Authorized Field Change

AFC 13910

Subject: Blower Motor Assemblies and Linear Power Module (LPM) Updates

Figure 2. Tape Adhered Between Evaporator and Black Plastic Case of Interior Module

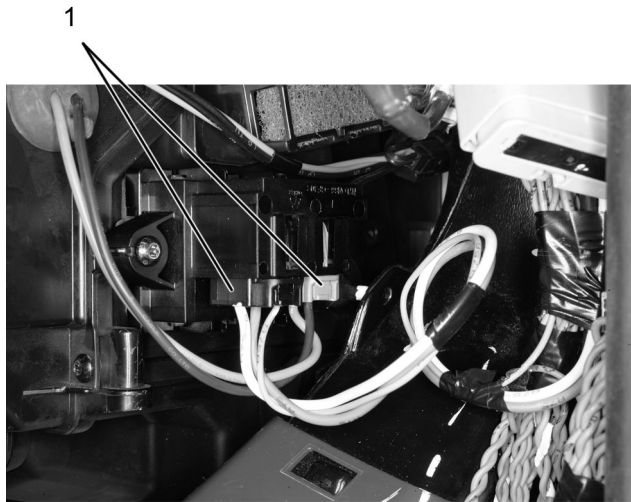
9. Fold tape lengthwise and apply tape to cover gap between gaskets (Figure 1, Item 1) on top of evaporator (Figure 2).

Figure 4. Linear Power Module Connections

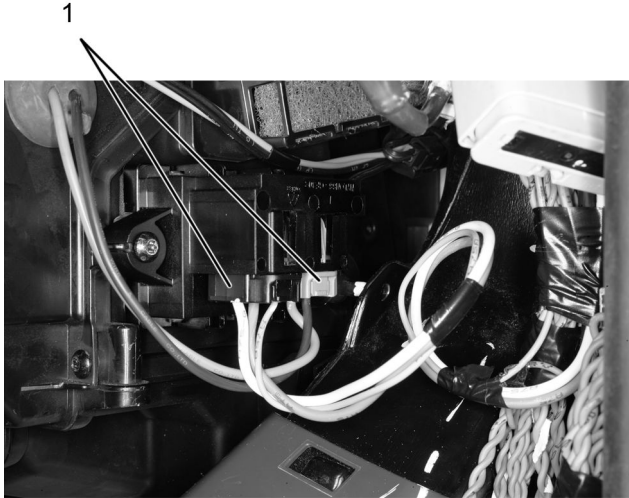
1. Linear Power Module Harness Connections (2).
2. Connect both harnesses to LPM (Figure 4).
3. Connect negative battery terminal.
4. Install battery box cover.
5. Remove wheel chocks.
